CHAPTER III

CHAPTER IV

Comments on the Draft EIR and Responses to Comments

Subject: Lawrence Berkeley National Laboratory 2006 Long Range
Development Plan & Draft Environmental Impact Report

FIGURE 8 . COMPILATION OF LANDSLIDE AND SURFICIAL GEOLOGY MAPS 13a-13f IN STRAWBERRY CANYON

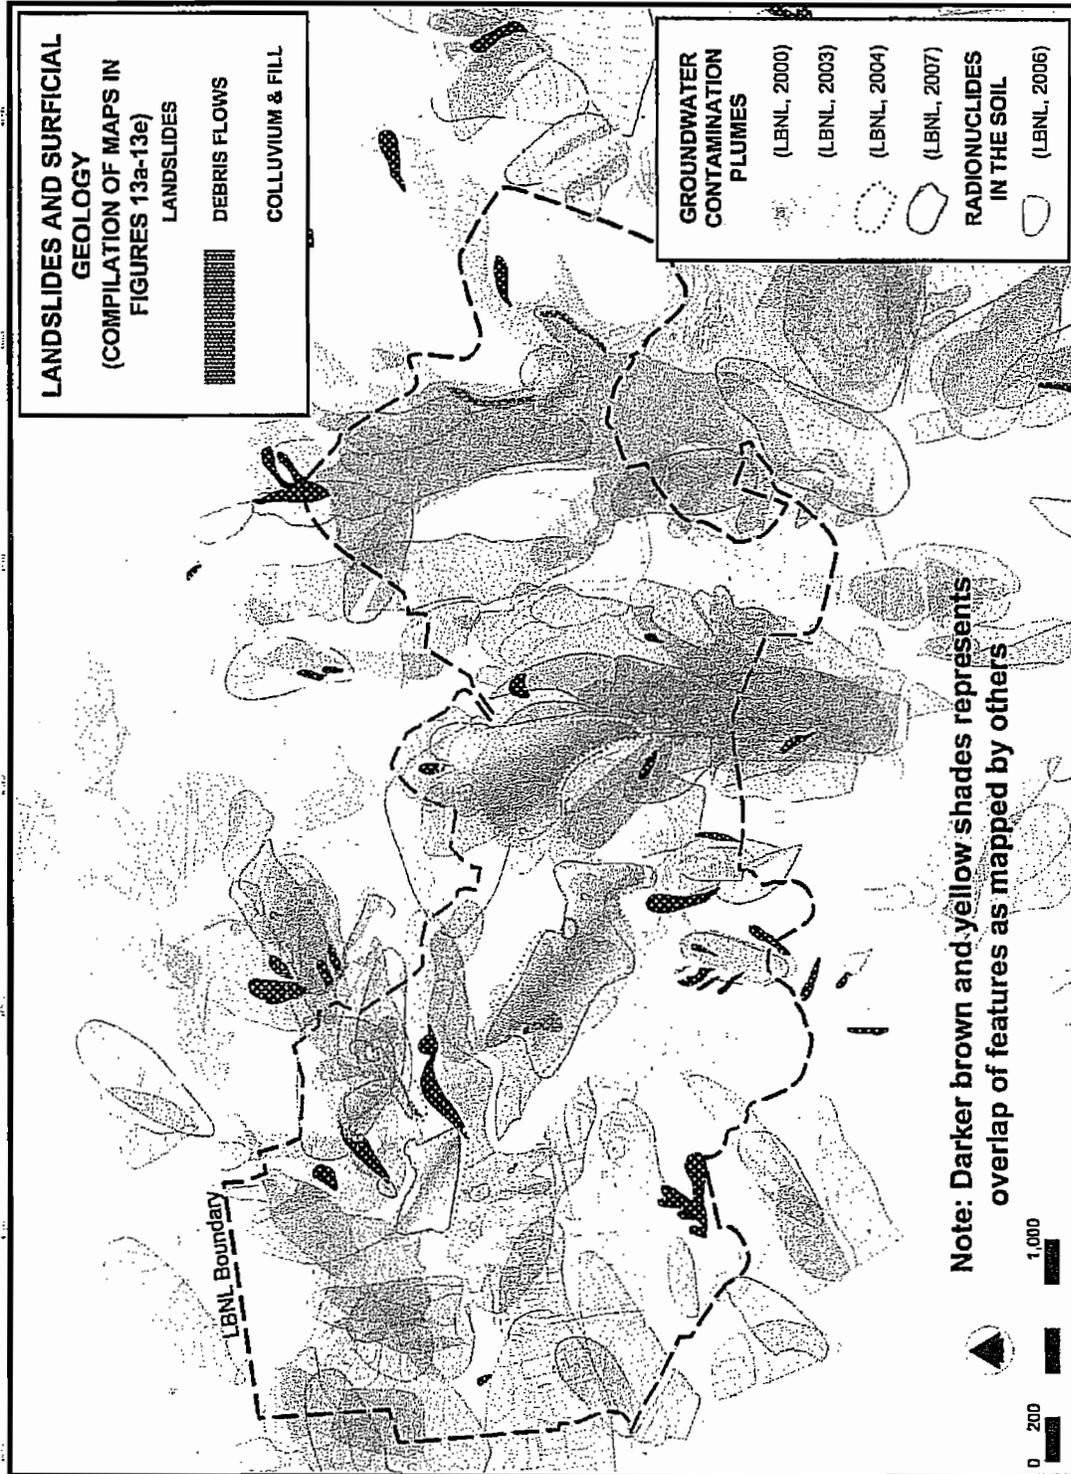
Figure 8 is a compilation of landslide and surficial geology maps in the Strawberry Canyon. It appears that all the above referenced new construction is proposed in major landslide areas of the Lab. The DEIR fails to evaluate the potential impacts from landslides, originating either from inside the Lab boundary or from outside the boundary effecting buildings and roads within LBNL as well as access roads to the Lab, such as Centennial Drive.

FIGURE 1.1 GROUNDWATER CONTAMINATION PLUMES AND RADIOACTIVE CONTAMINATION IN SOIL AND RELATION TO FAULTS AND EARTHQUAKE EPICENTERS AT LBNL IN STRAWBERRY CANYON

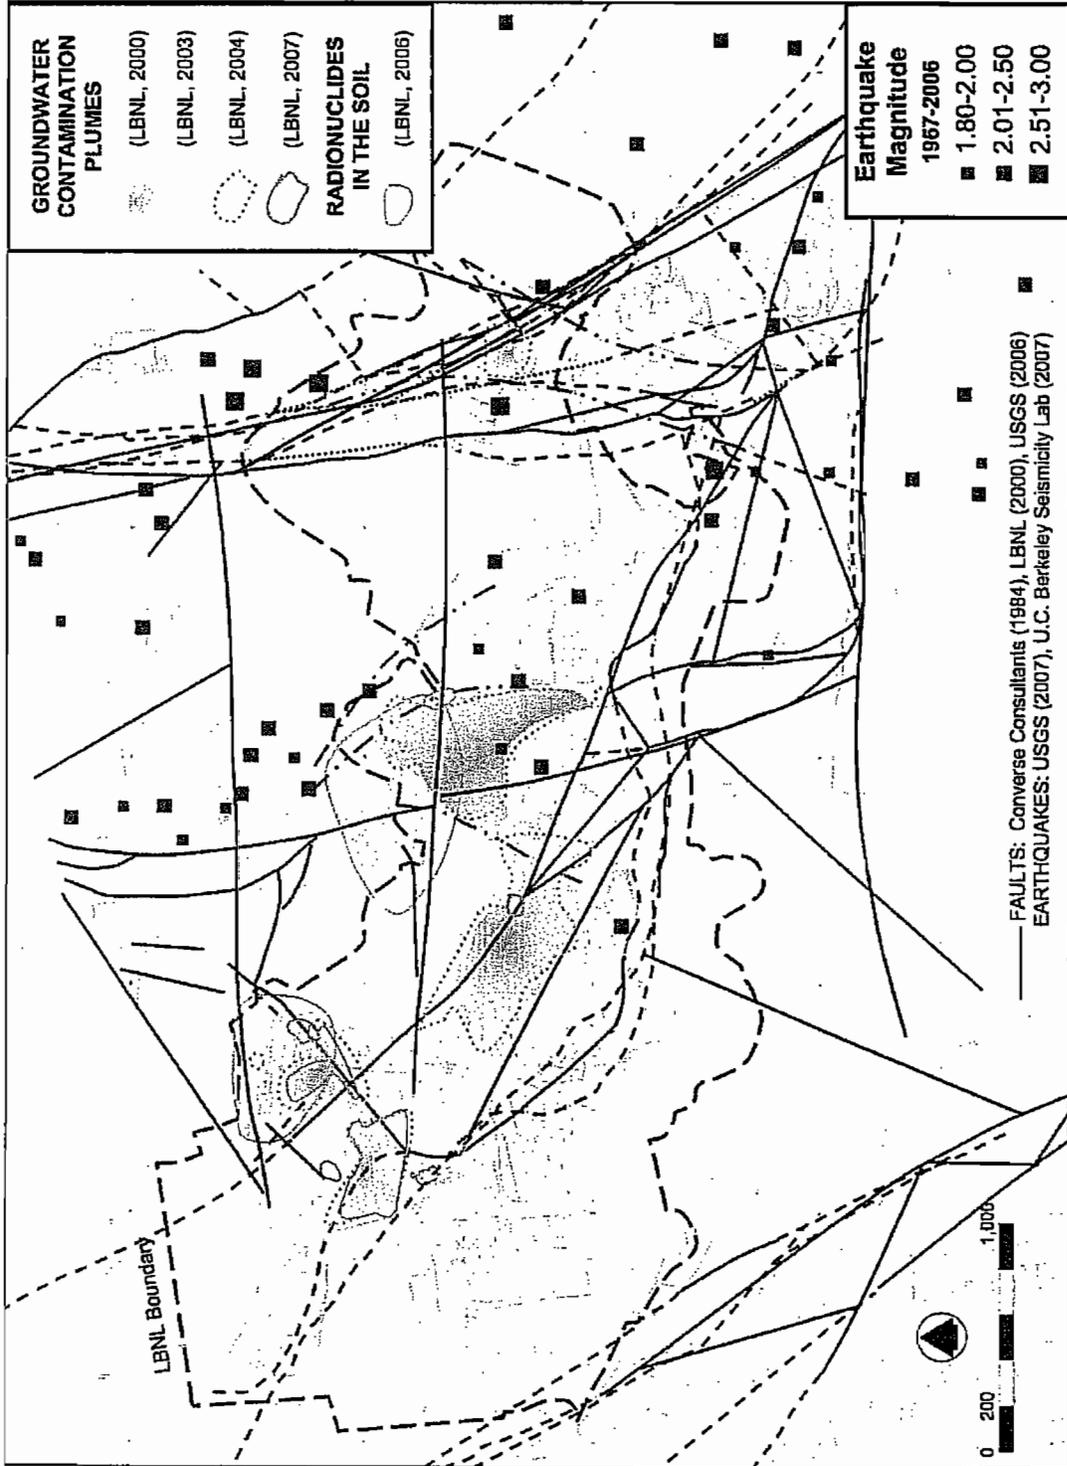
Figure 11 shows earthquake epicenters and faults (fault interpretations) in the Strawberry Canyon. The DEIR fails to describe the entire Hayward Fault Zone in detail, which is the area reaching from the Hayward Fault to the East Canyon and Wildcat Faults.

FIGURE 1 2. ZONES OF CONCERN FOR GROUNDWATER PLUME EXPANSION ALONG FAULTS, BEDROCK CONTACTS, LANDSLIDES. HISTORIC CHANNEL BEDS AND MODERN CREEKS. SEE NEXT PAGE FOR MAP LEGEND.

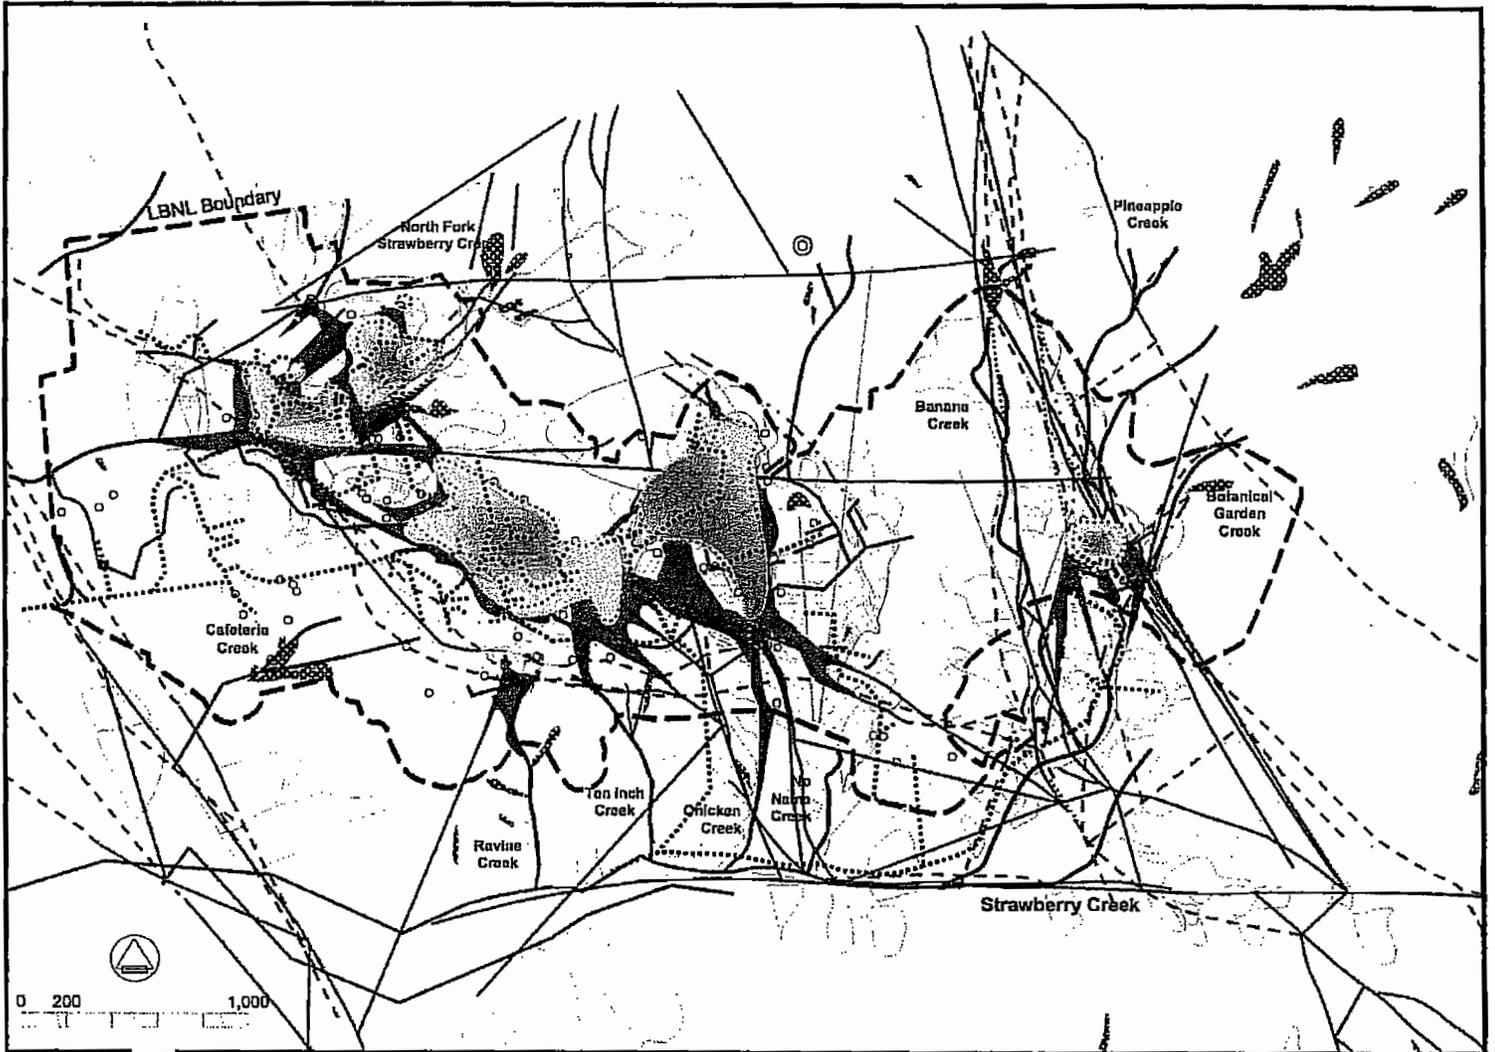
Faults in the Canyon are also potential conduits for the migration of contaminated groundwater at LBNL. Figure 12 shows Zones of Concern within the mapped groundwater contaminant plumes, and indicates areas where additional sampling should be conducted. The DEIR fails to address the dangers of proposed new development over areas of groundwater contamination and within the Zones of Concern.

The depiction of a number of the faults shown on the figures included with the comments, including Figure 12 showing the “Zones of Concern” is inaccurate, and a number of the depicted faults do not exist. Specifically, the existence of several of the faults shown on the map., including the University fault, New fault, Space Sciences fault, and members of the Lawrence Hall of Science fault complex was based solely on conjectured groundwater flow suggested in an early landslide study, and not on field observations. Subsequent detailed geologic and hydrogeologic studies conducted at LBNL have yielded no evidence to support their existence.

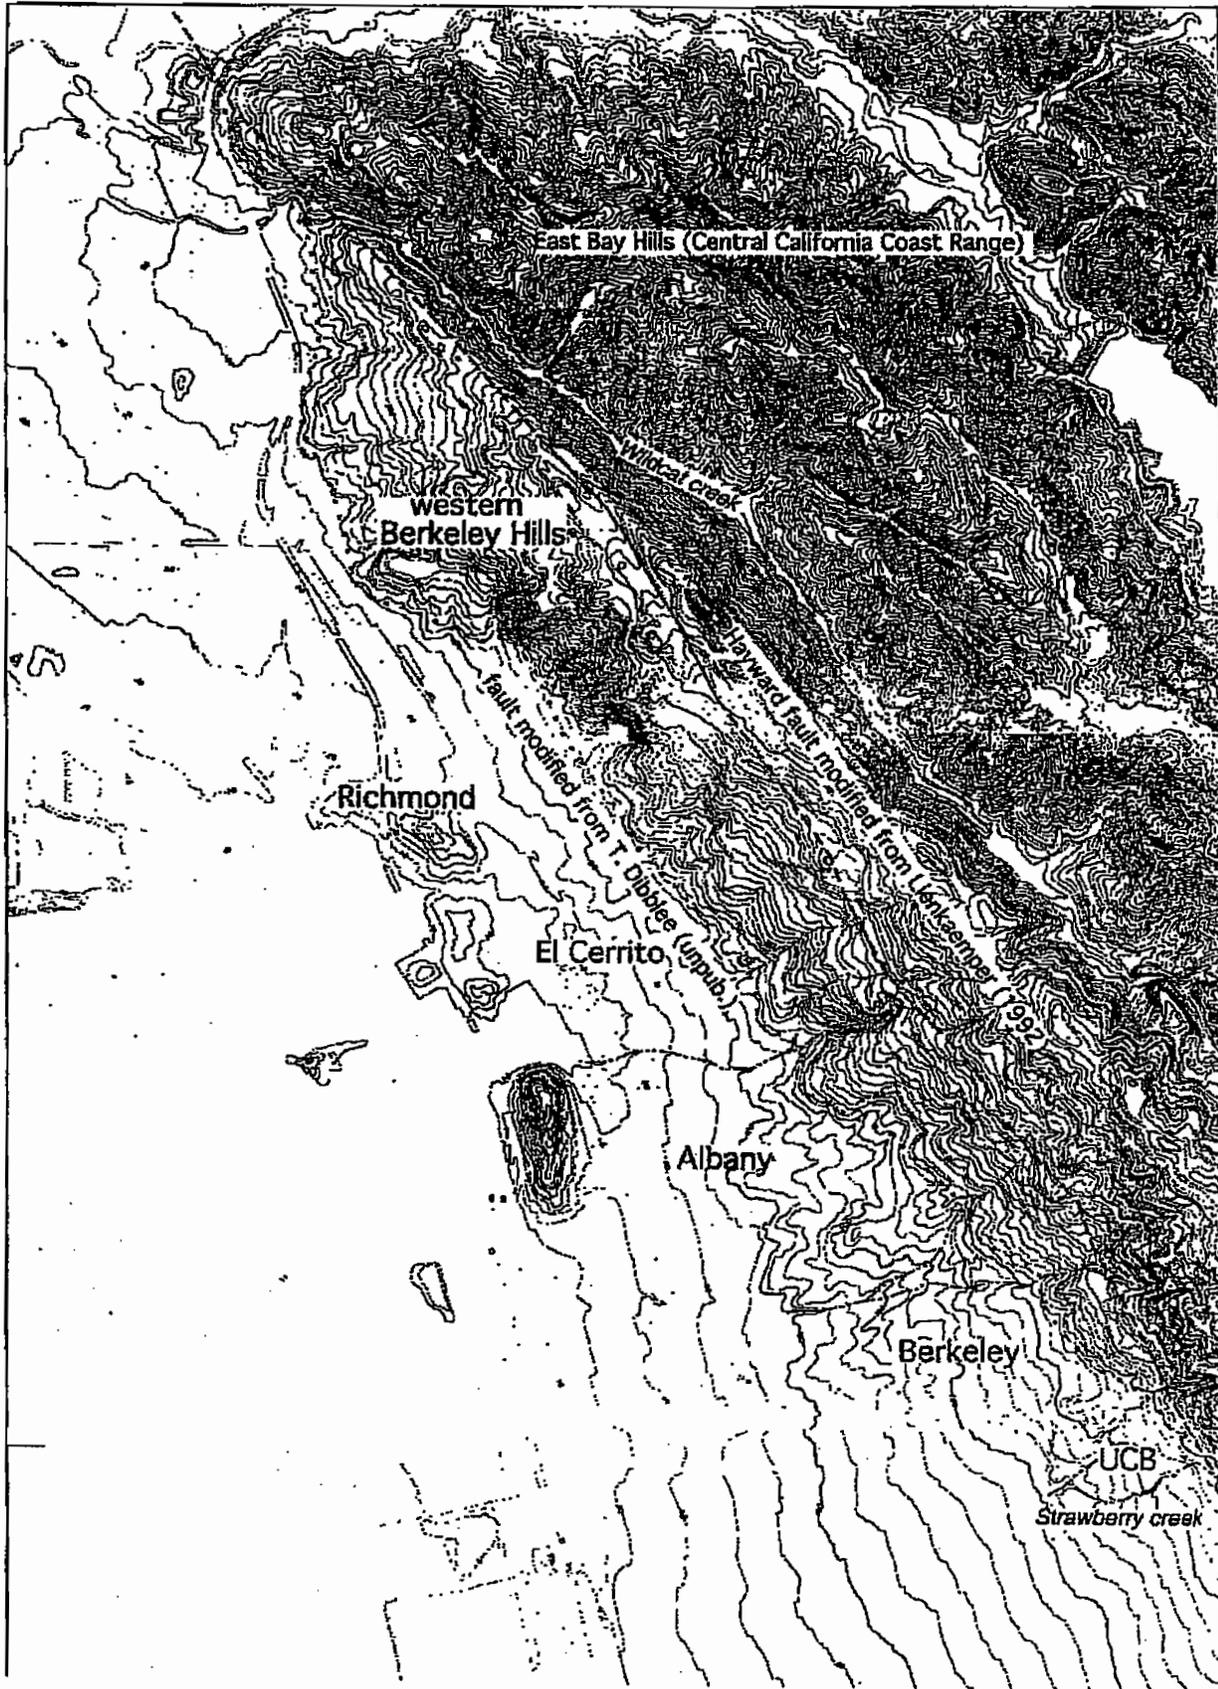
Landforms of the western Berkeley Hills support a hypothesis of uplift to the west of the fault. The Hayward fault traverses the hills ([Figure 2](#)) between Strawberry Creek and Richmond. Dibblee (unpublished mapping of the Richmond and Oakland East quadrangles) mapped a faultline at the base of the hills, as illustrated in [Figure 2](#), and labeled as the El Cerrito fault. The Hayward fault climbs from 400 feet at Strawberry Creek to 800 feet at the crest of the western Berkeley, a rise of 120 meters. If the about 0.5 mm/yr rate of vertical motion suggested by the apparent uplift of abandoned Strawberry Creek channels holds for long period required for uplift of the western Berkeley Hills across the Hayward fault, the period required to reach their present configuration is approximately 250,000 years. Lack of a well-developed fault-line valley along the relatively more stable ridge-top area also suggests the youthfulness of the present configuration. It is thus proposed that the western Berkeley Hills block has been upthrust between the El Cerrito and Hayward faults during Quaternary time

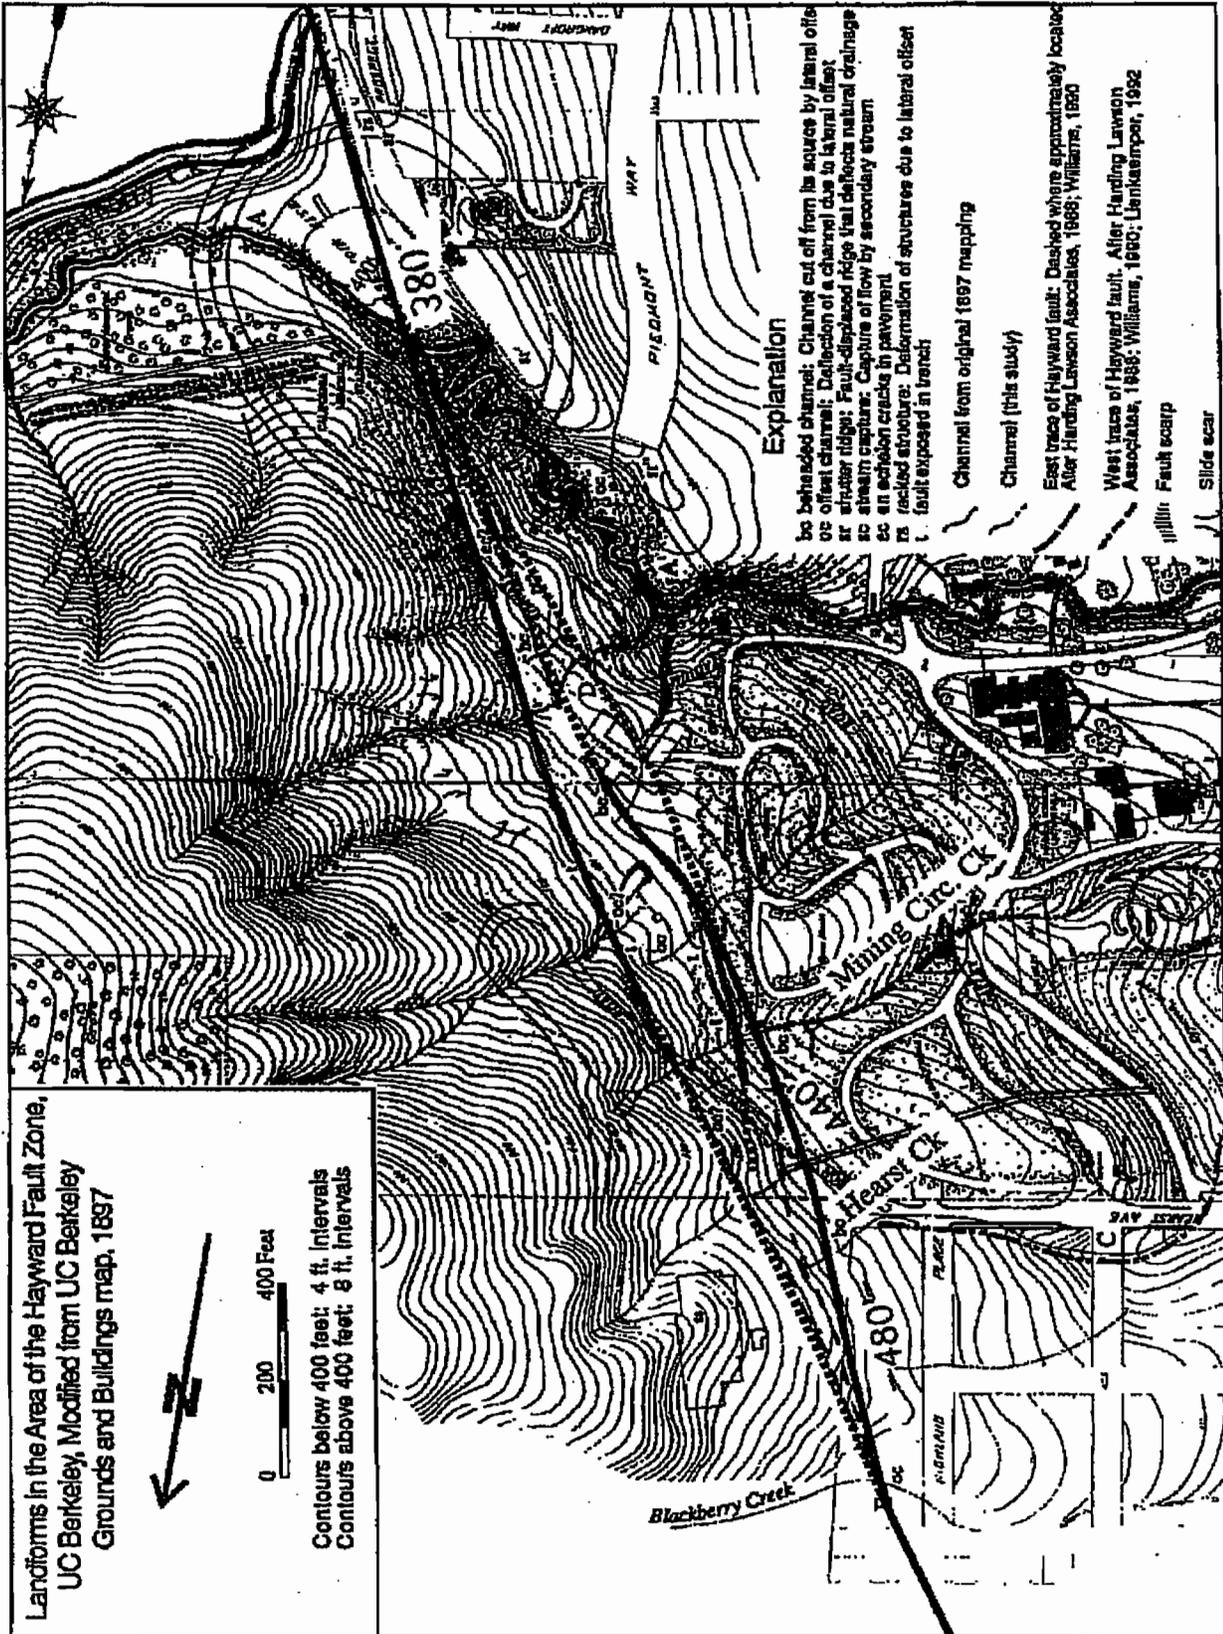
The earliest detailed landform map in the Hayward fault zone is the UC Berkeley building and grounds map, compiled in 1897 ([Figure 3](#)). This map records the morphology of the abandoned Mining Circle and Hearst channels of Strawberry Creek at a contour interval of four feet. The fault climbs approximately 24 meters across this Figure (from 400 to 480'). Once again, the offset channels project to the fault at about 440 and 480 feet. Note that the near-fault profile of each beheaded channel is steepened by alluvium, which heightens the apparent channel intercept with the fault zone. A better estimation of the height of the intersection can be made by projecting the stream profiles from a greater distance from the fault ([Figure 4](#)). Note also the area of thickly ponded alluvium behind the Strawberry Creek shutter ridge. This ponding causes a tendency to underestimate the depth of the Strawberry Creek Canyon, and consequently underestimate the total vertical separation between the canyon and the beheaded channels. A projection to the fault of the bedrock stream profile is thus required to estimate the Wisconsin-era canyon morphology, and to recover the maximum vertical separation of the beheaded profiles.
